St. Bernard Parish Library
Construction Documents Review by Staff
July 13, 2020

After reviewing the construction documents, and assuming that this library will be used for many years, and that running additional wires during the construction phase is a LOT cheaper than putting them in after the building is complete, the staff, especially Dwight, has made the following professional observations:

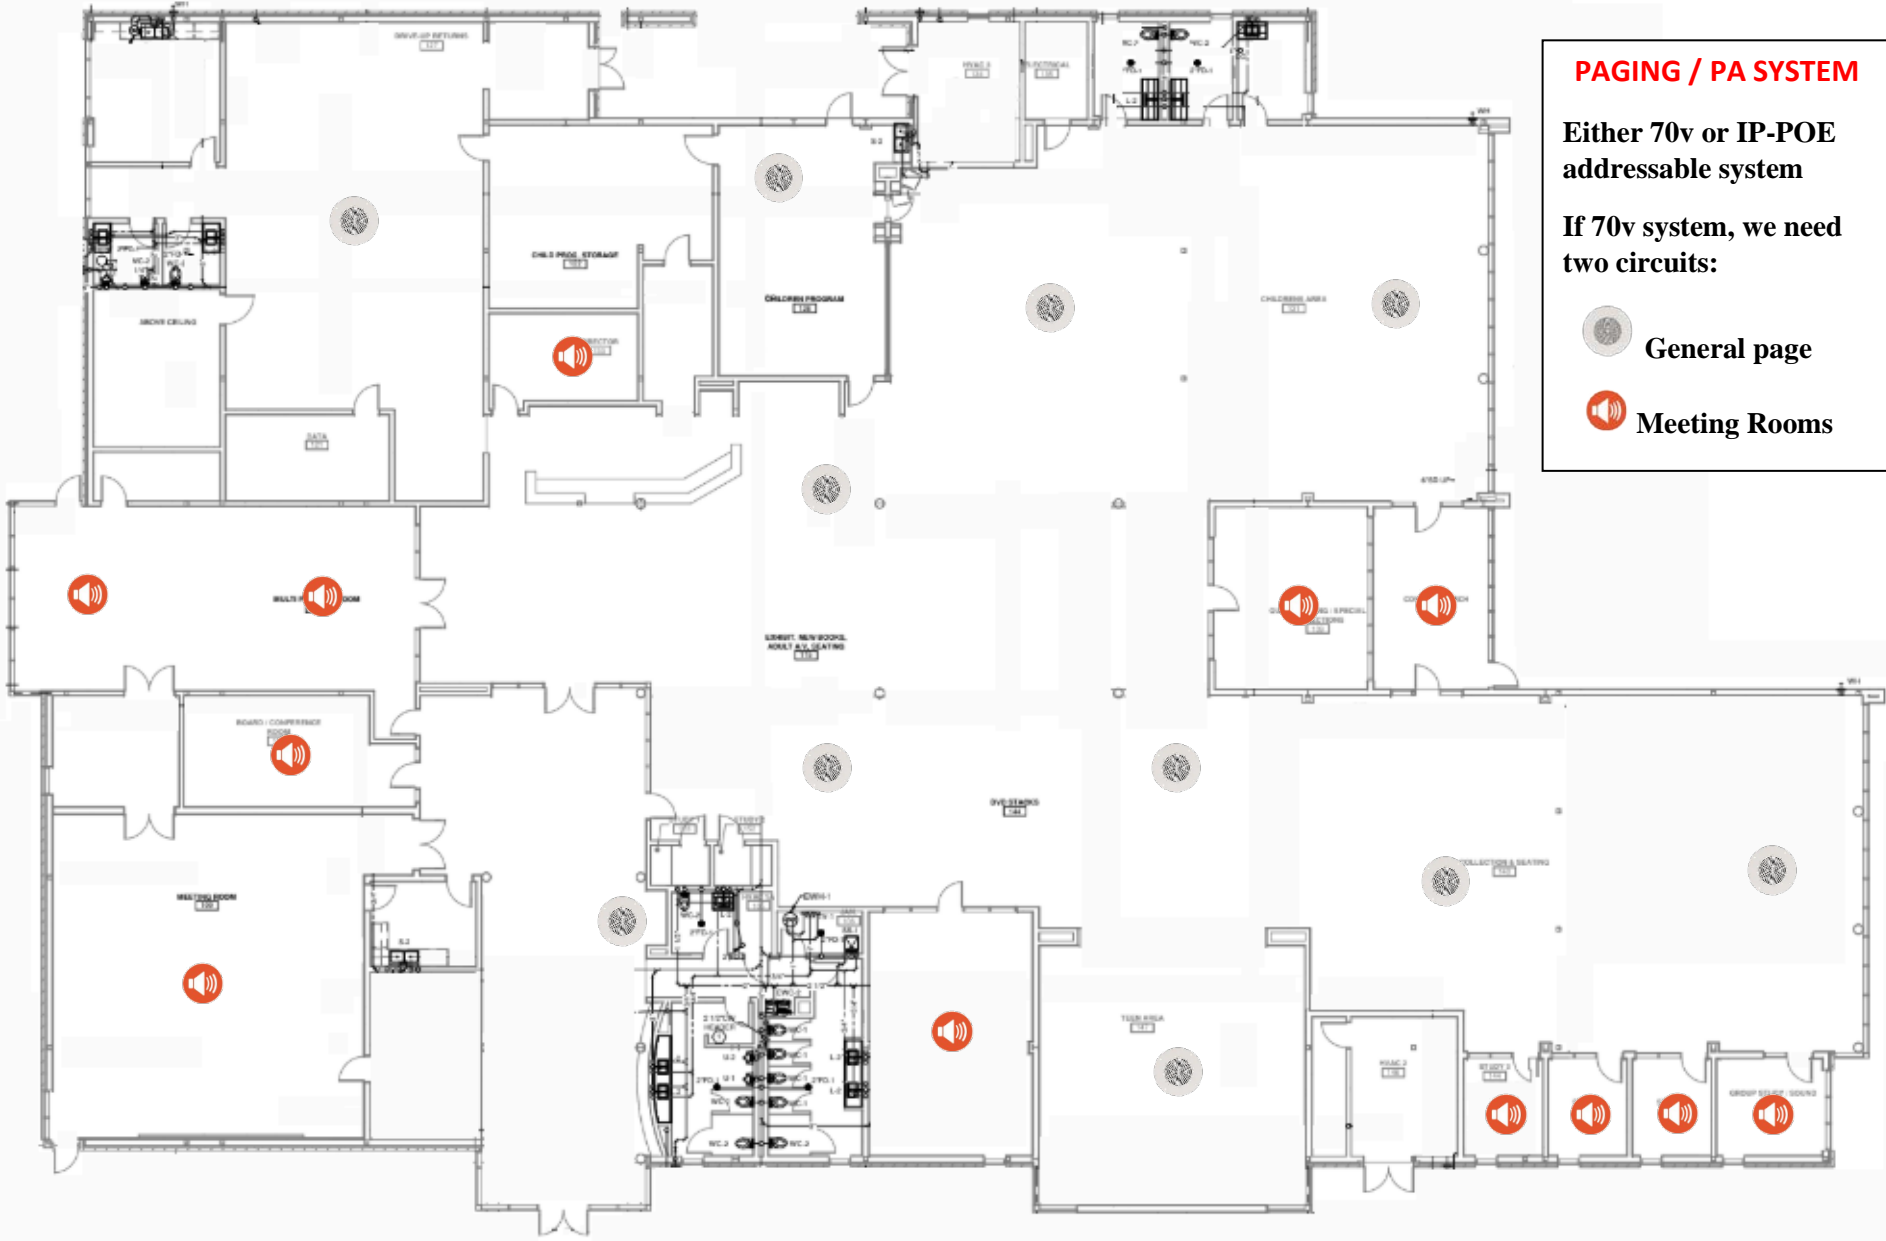
Where are the communications providers (Cox & ATT) going to get their feed into the building?

Southwest corner of building needs to have a covered outlet box near roof containing 3 RG-6 coax wires and one bare copper ground wire for future satellite and/or antenna wires in conduit to the server room.

Cement riser pads with power and data for outdoor marquee signage (viewable both directions of travel)

Master On/Off Lighting Switches for Open Areas

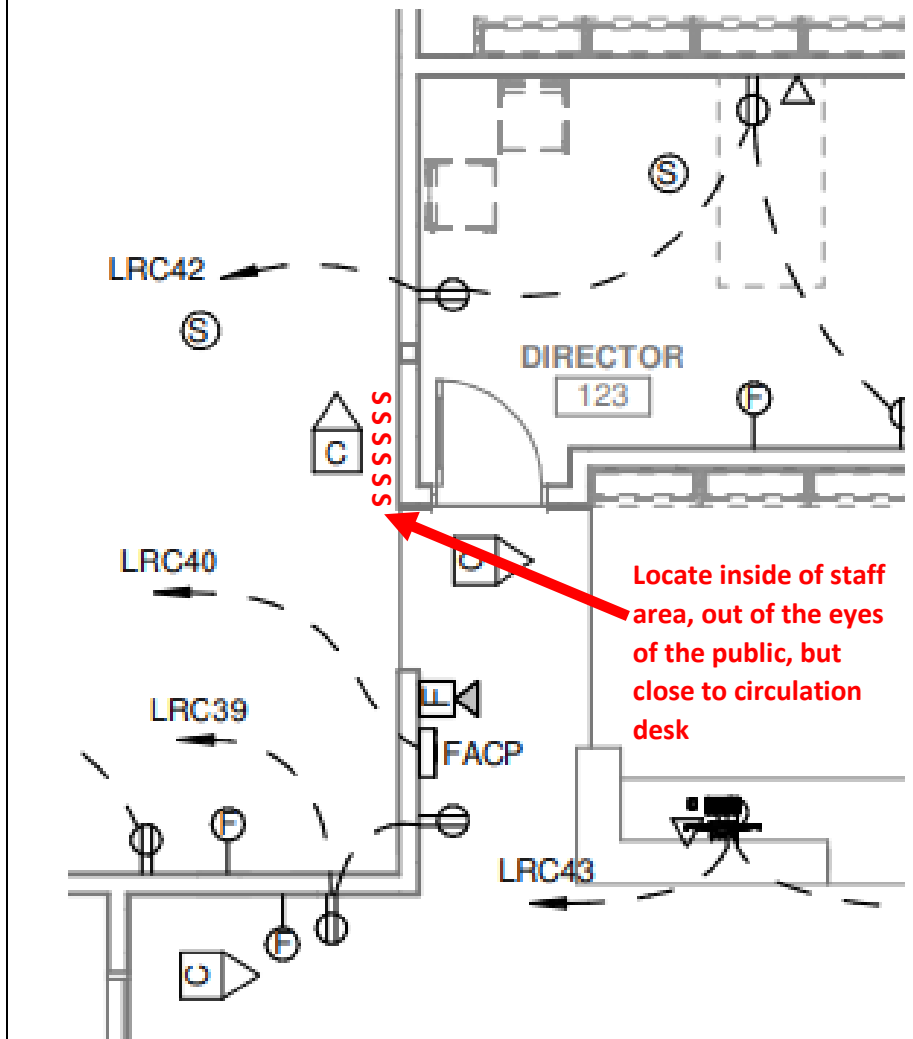
Locate inside of staff area, out of the eyes of the public, but close to circulation desk

Additional Floor Outlets

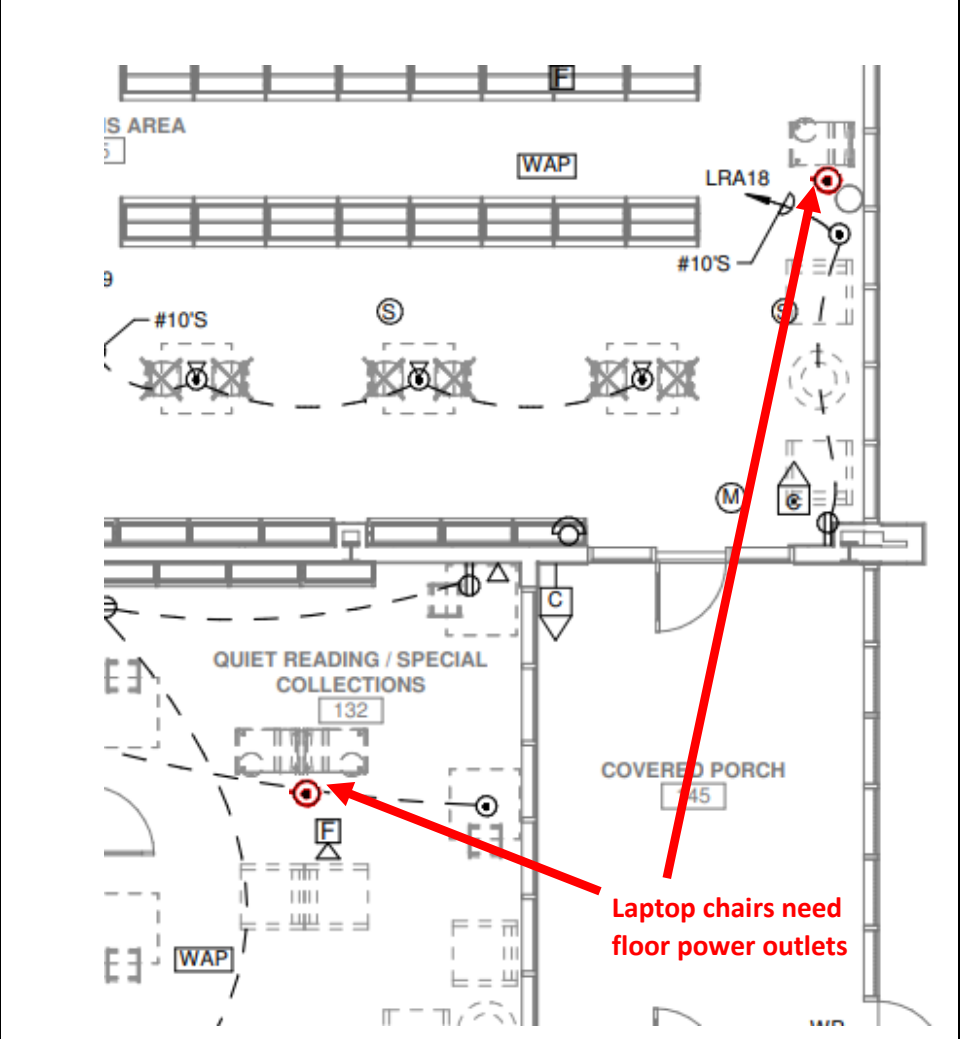
Laptop chairs need floor power outlets

ELECTRONIC DOOR LOCKS

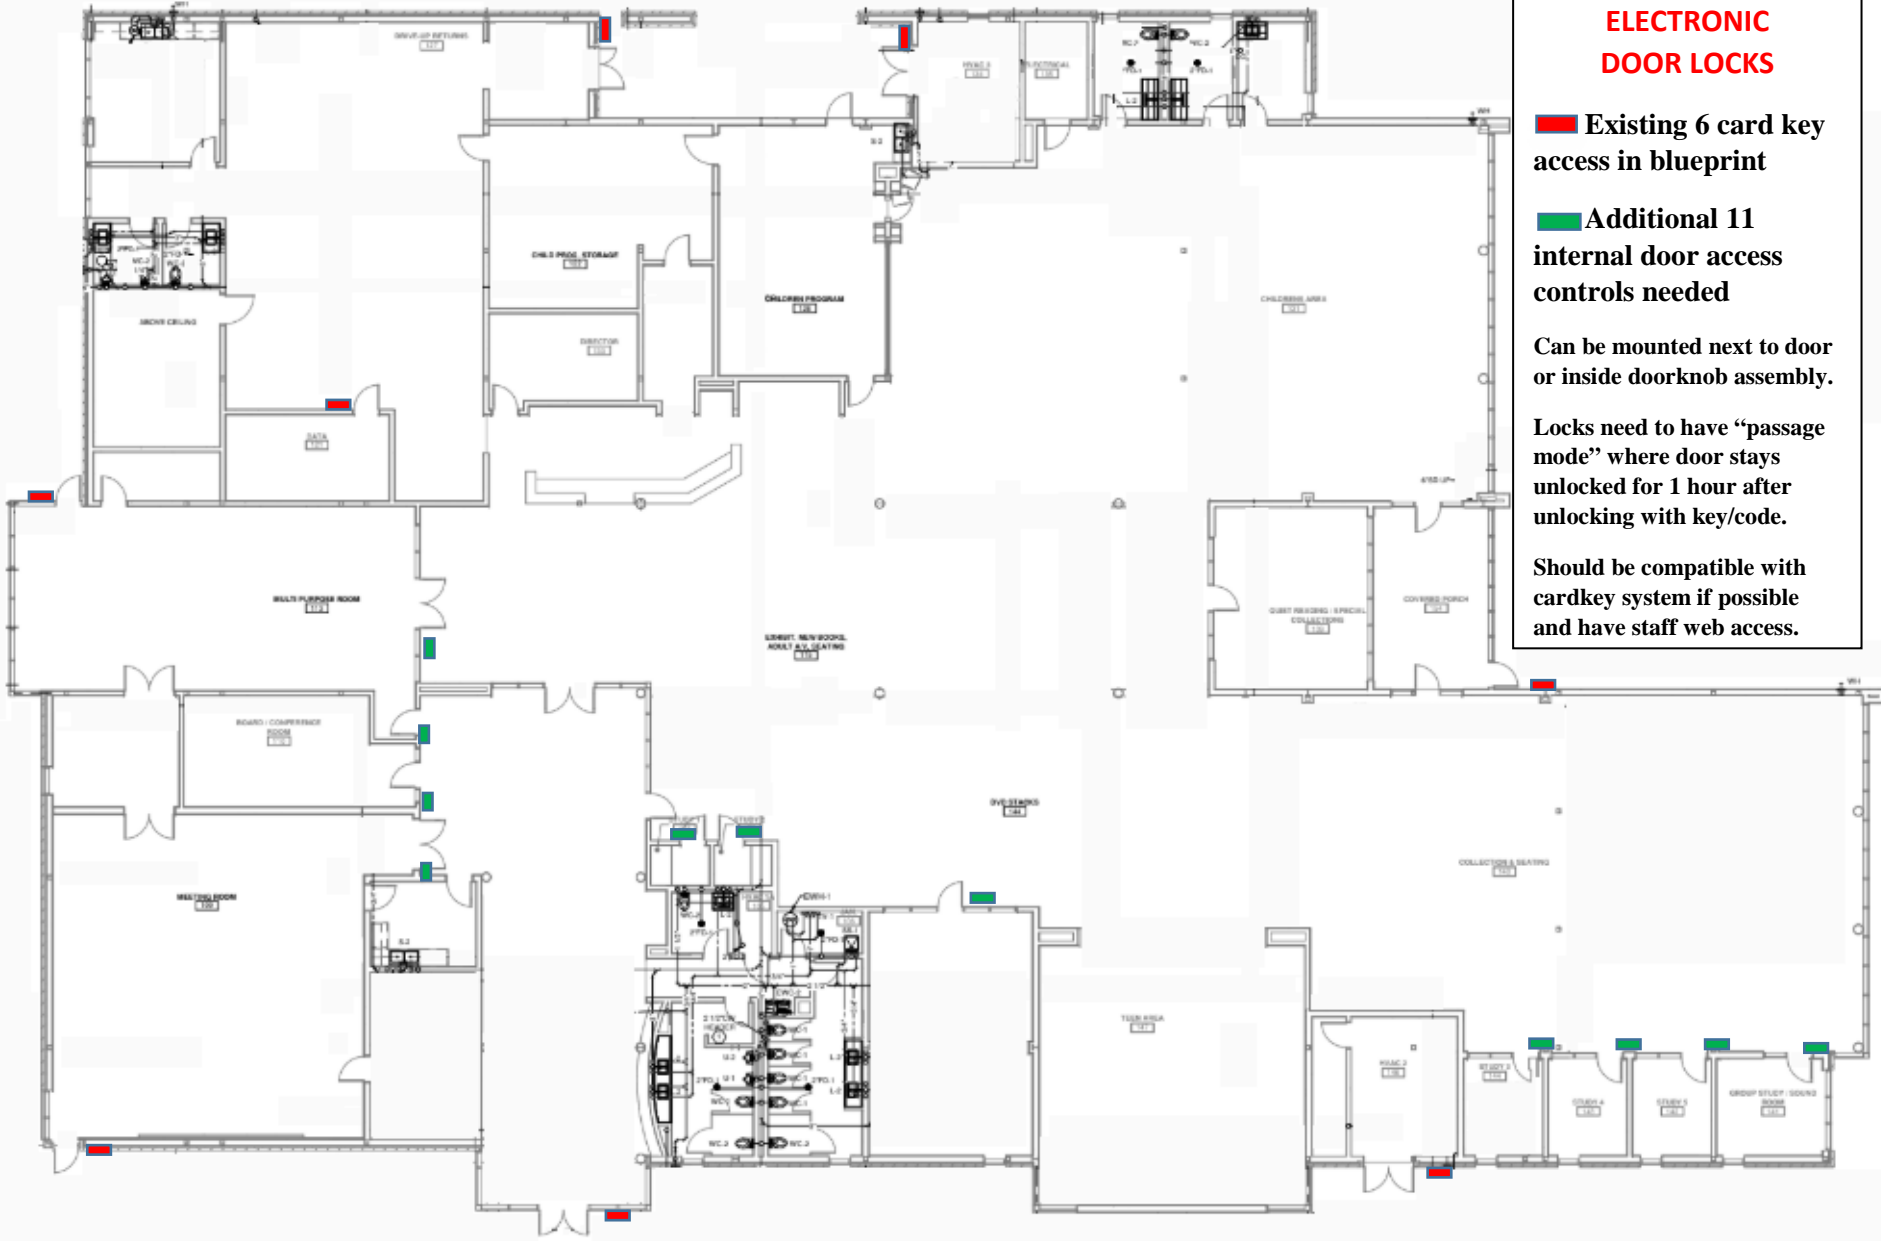
Existing 6 card key access in blueprint

Additional 11 internal door access controls needed

Can be mounted next to door or inside doorknob assembly.

Locks need to have “passage mode” where door stays unlocked for 1 hour after unlocking with key/code.

Should be compatible with cardkey system if possible and have staff web access.

DATA ROOM and RACK WIRING

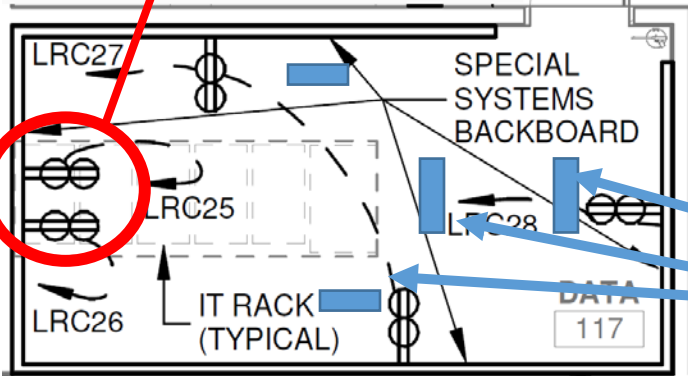
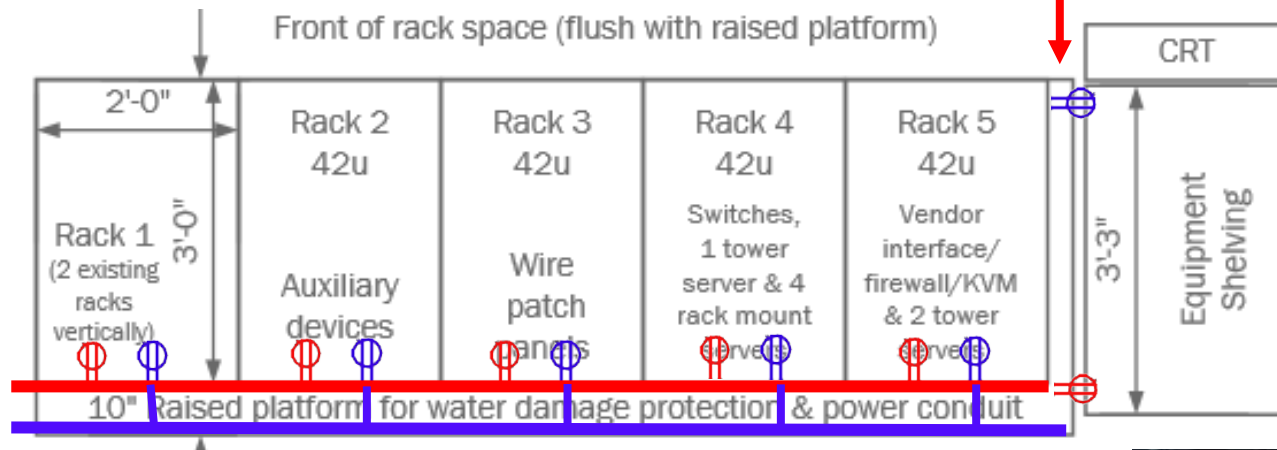
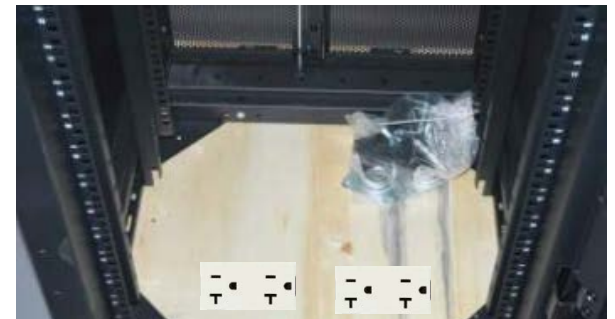
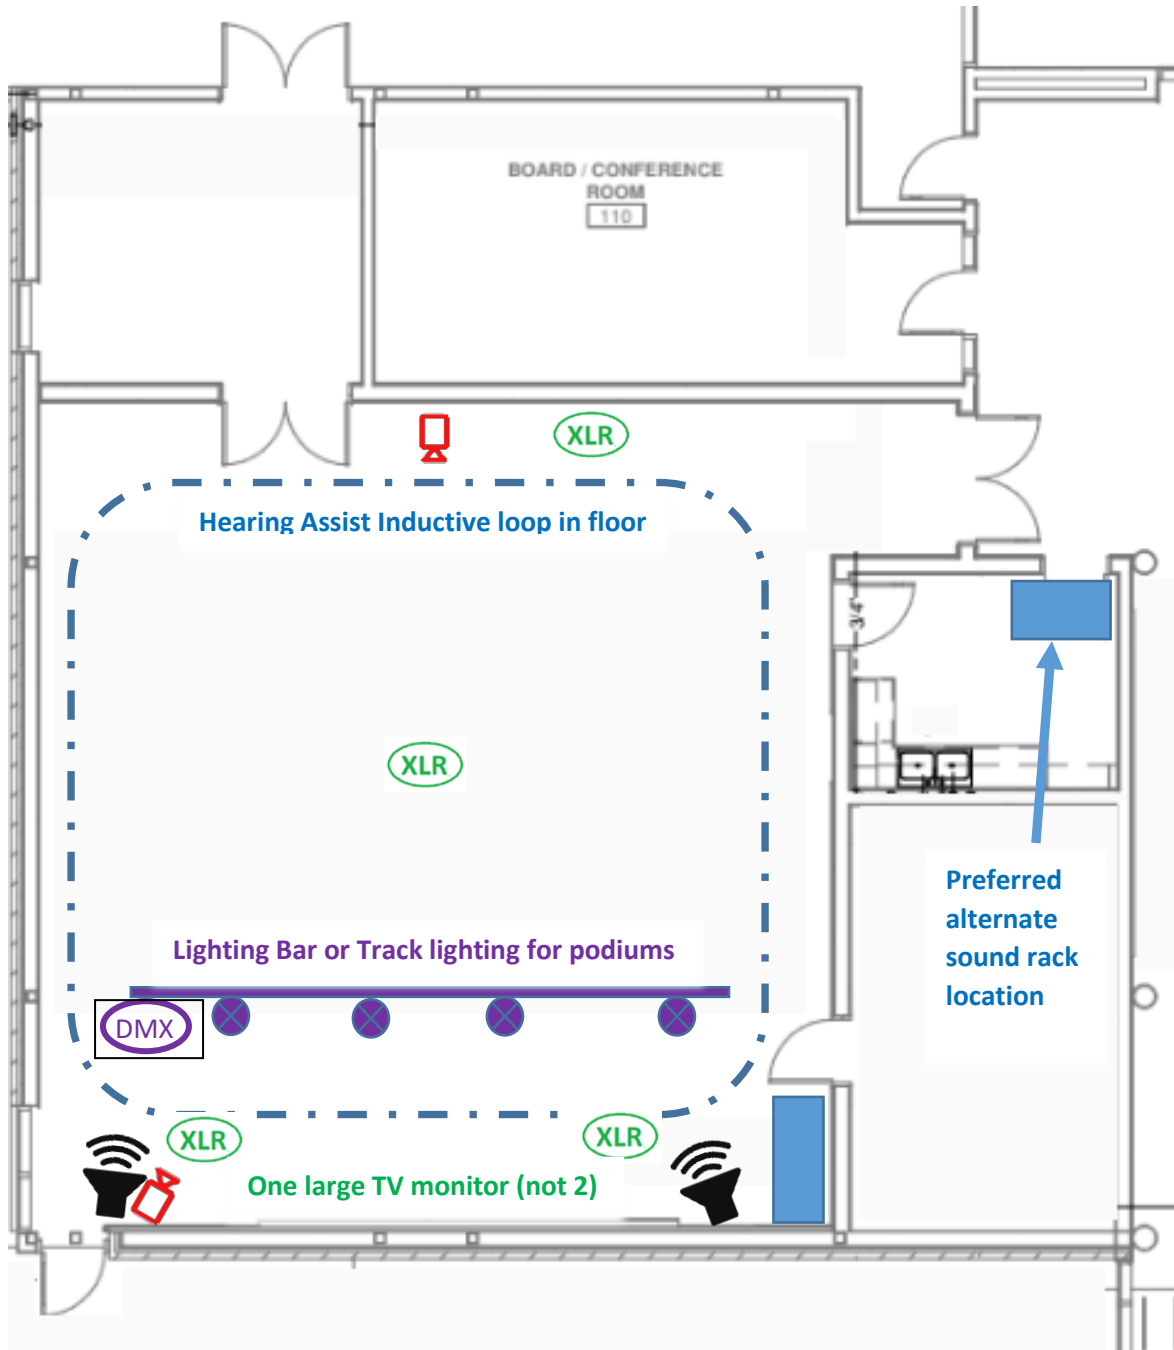
10. **Data room changes.** The power layout for the racks is clumsy and inadequate. The existing plans would require long cords from each rack to be strung along the other racks to reach the outlets shown on the wall. In the original design meeting with the architects, we discussed having an offset on the racks in the back of the raised pedestal to route power to each rack individually, which is shown. Our servers have dual power supplies and need two different power circuits in each rack in case one circuit fails. In addition, there needs to be some sort of ceiling-mounted raceway bracket system mounted between the racks and the north, east, and west walls, so that wiring from wall-mounted staff and vendor equipment can reach without being a tripping hazard (in lieu of a raised floor). OK.

Wall-mounted outlets for racks should NOT be used. Instead, see images below.

Ceiling-mount raceway brackets

Outlets in shelving wall for CRT and Aux Equipment Shelf

2 Separate power circuits (marked red & blue) for power fail-over in each rack located inside the bottom rear
